### TECHNICAL SERVICE BULLETIN "E" - 78 - 1533

Subject: Hydraulic Adapter, Part No. 18818, Used on 800 Series Hydraulic Equipped Tractors and G.M.T.

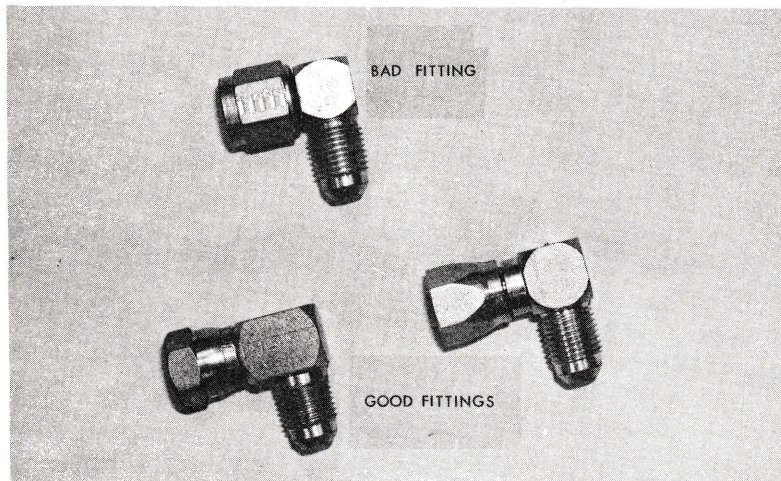
We have received adapters from three manufacturers under part number 18818. One type has been found to be defective. The defective adapters can be identified by the nut section.

Please notice the difference in the nut style of the defective adapter and the good adapter. Destroy all defective adapters in inventory and submit a warranty request for compensation.
